## ADDENDUM # 1

RFP-735-18-4285

Moffett Library Reading Room Asbestos Abatement  
Midwestern State University  
3410 Taft Blvd., Wichita Falls, TX 76308

ISSUE DATE: September 26, 2018

Second Floor Drawing

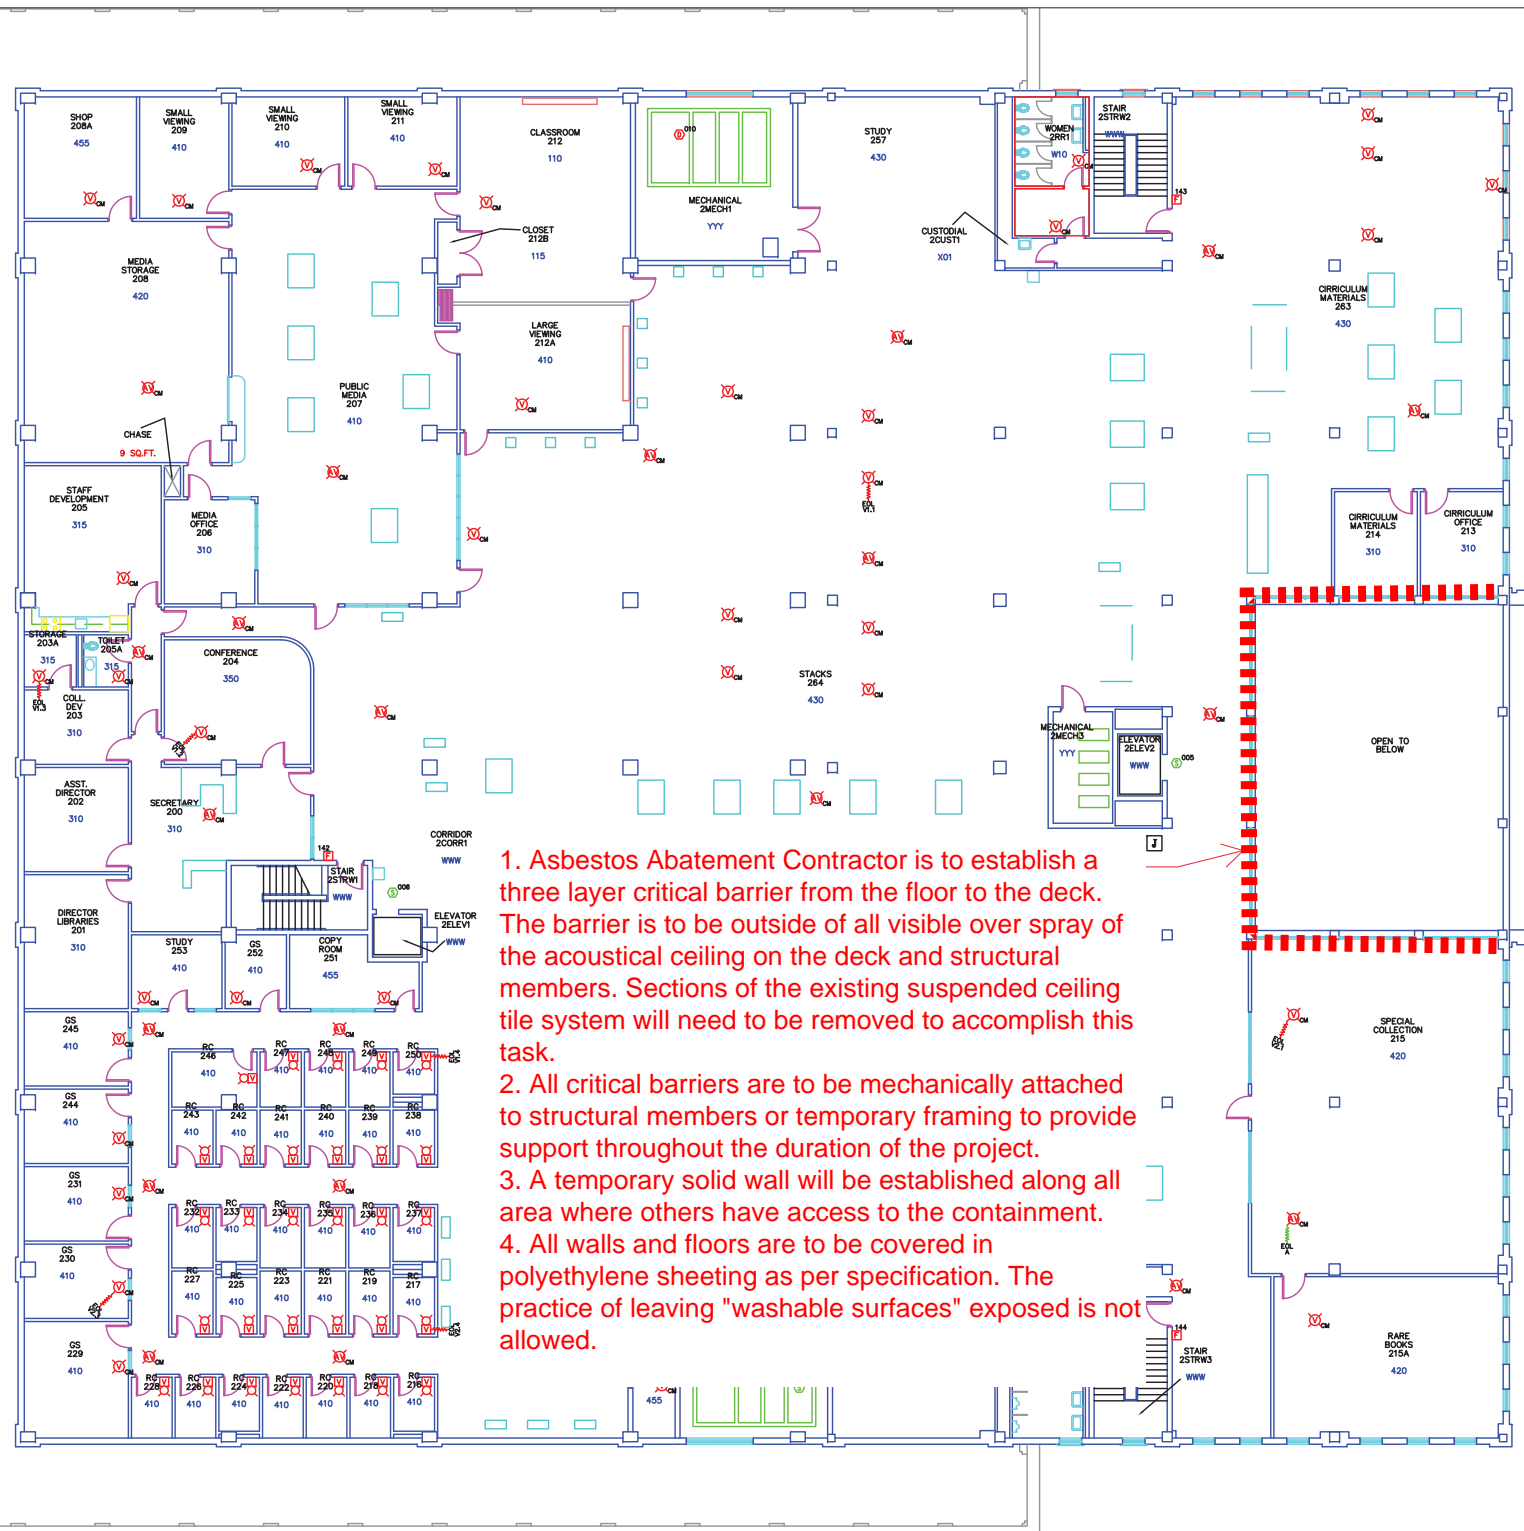
1. Asbestos Abatement Contractor is to establish a three layer critical barrier from the floor to the deck. The barrier is to be outside of all visible over spray of the acoustical ceiling on the deck and structural members. Sections of the existing suspended ceiling tile system will need to be removed to accomplish this task.
2. All critical barriers are to be mechanically attached to structural members or temporary framing to provide support throughout the duration of the project.
3. A temporary solid wall will be established along all area where others have access to the containment.
4. All walls and floors are to be covered in polyethylene sheeting as per specification. The practice of leaving "washable surfaces" exposed is not allowed.

Arch to be  
abated
